Application no: H16/0061/93

Description: The demolition and rebuilding of a section of Ayscoughfee Gardens wall adjacent to Love Lane

Location: Ayscoughfee Gardens
Ayscoughfee Hall
Churchgate
Spalding

PLANNING AND LISTED BUILDING APPLICATIONS
DEMOLITION AND RE-BUILDING SECTION OF WALL ADJACENT TO LOVE LANE, SPALDING.

ELEVATIONS

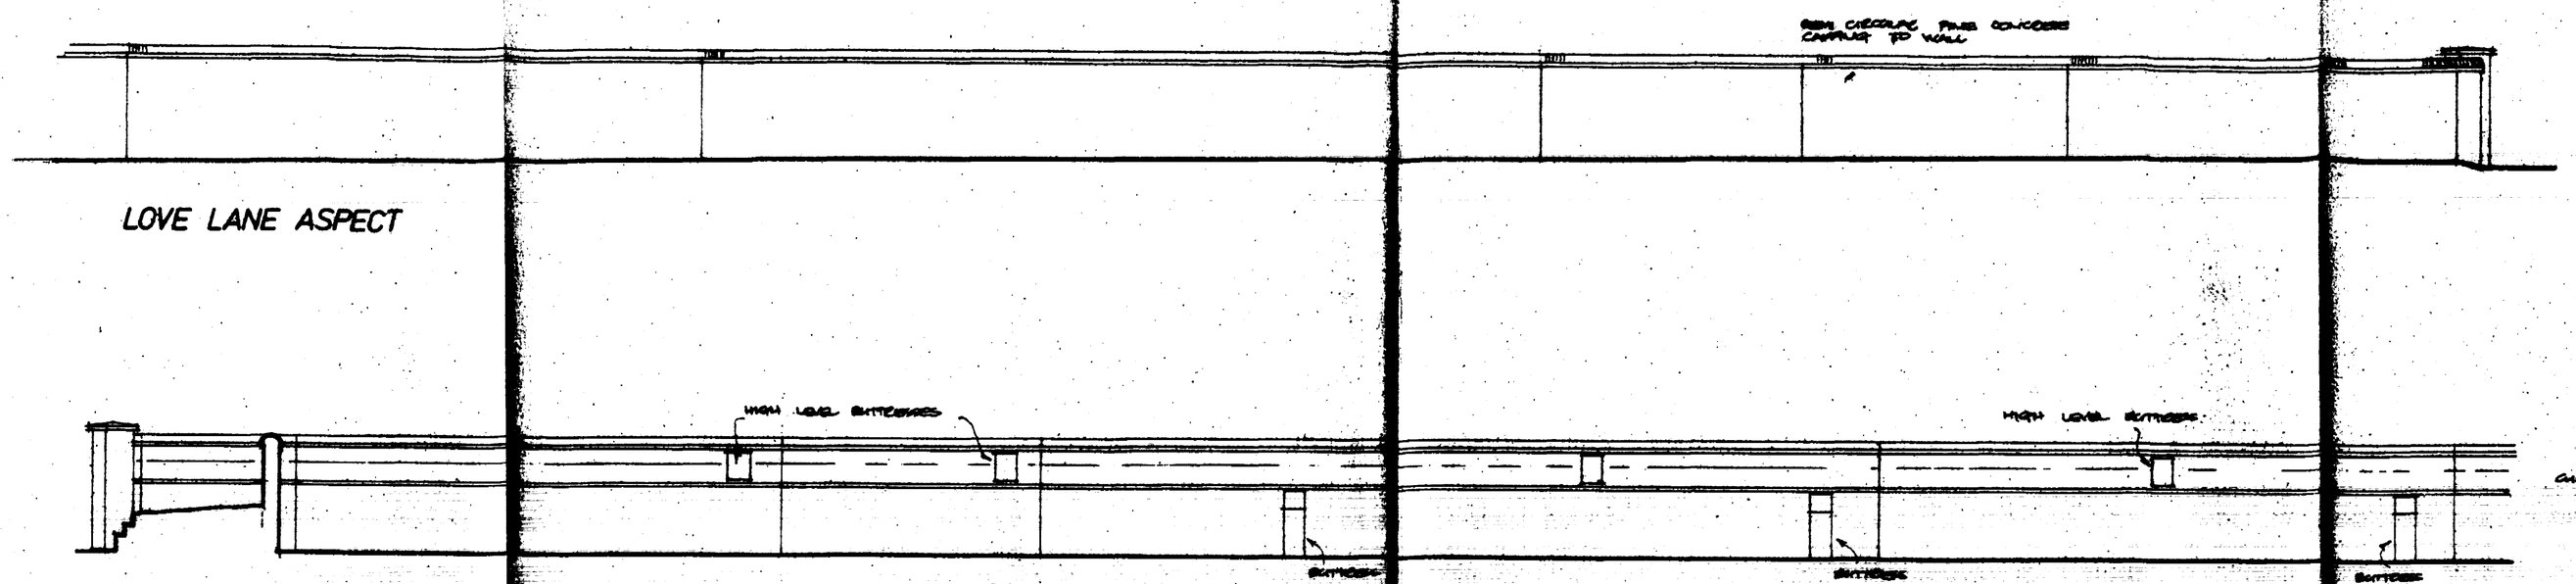
Thank you for your notification dated 8 February. I have inspected the wall in passing and would question whether the proposed demolition is either neccessary or desireable. Although the brickwork of the wall has suffered considerably from the consequence of unsuitable hard pointing, it appears reasonably plumb in most of the section proposed for demolition, and shows few obvious signs of distress.

I confirm the conclusion of the meeting between our Officers that the original intention of demolishing and rebuilding, in its entirety, approximately 33.00m of wall was now to be rejected and it was resolved to only demolish and rebuild approximately the upper half of the sections of the wall in the vicinity of positions 6 and 5 on my drawing A/2/3, which shows the most definite signs of leaning.

PROPOSED

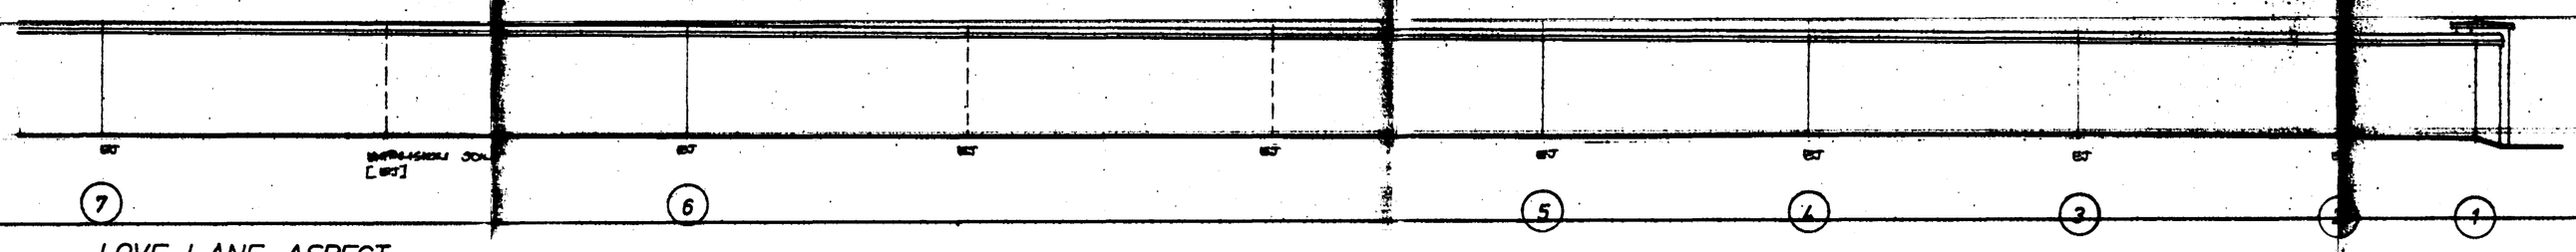
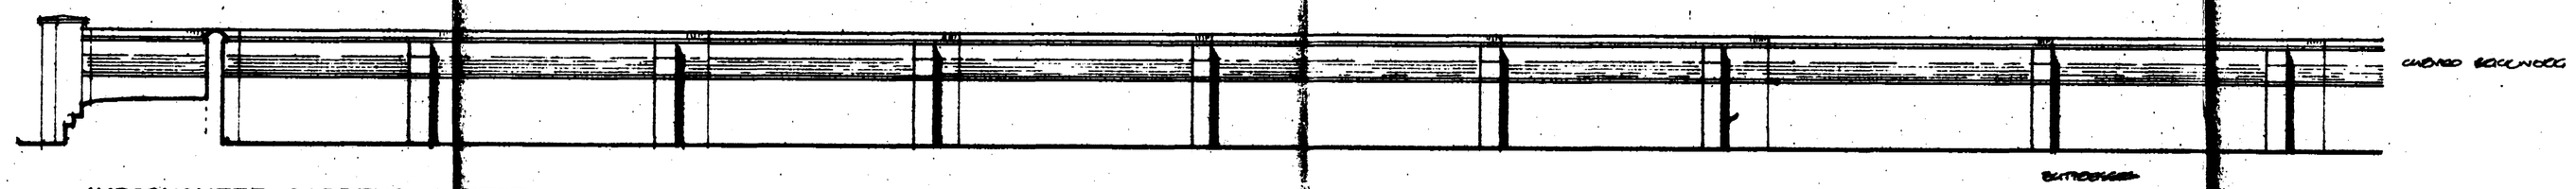
Bricks used in rebuilding should be second hand and selected to match the existing in colour and size. Care should be taken when repointing to ensure that the damage that was previously caused (to the boundary wall) is not repeated.

As a separate issue I have discussed the proposal with the Building Control Section who have drawn my attention to the BRE Good Building Guide No 13. In relation to this they are concerned that the proposal exceeds the permissable heights recommeded for a one and a half brick wall in a sheltered zone 2 condition. The matter is worsened by the fact that the walls are also acting as a retaining structure and should be structurally designed. The top third of the wall has also been reduced in thickness to one brick, and the maximum height for a one brick thick wall is 1750mm. The overall wall falls outside the permitted parameters as contained in the BRE guide.

PLAN ON EXPANSION JOINTS 1:5

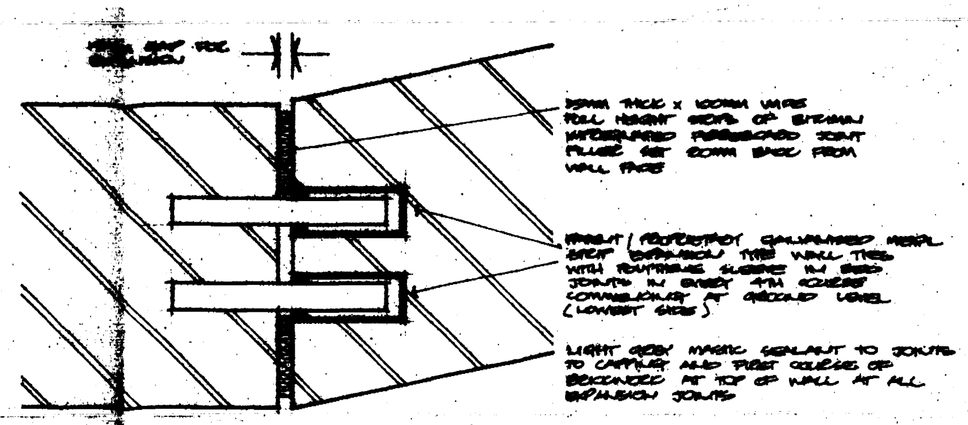
I am concerned to note that the proposed replacement wall contains continuous vertical expansion joints. It would be visually preferable if these could be designed out of the structure.

At this stage I am happy to continue to proceed with the applications as they stand, with the proviso that you will explore the possibility of 'designing out' the continuous expansion joints. You may care however to discuss the question of the advice contained within BRE guide No 13 with the Principle Building Control Officer, Mr Stuckey, and advise me if any further amendments are required.
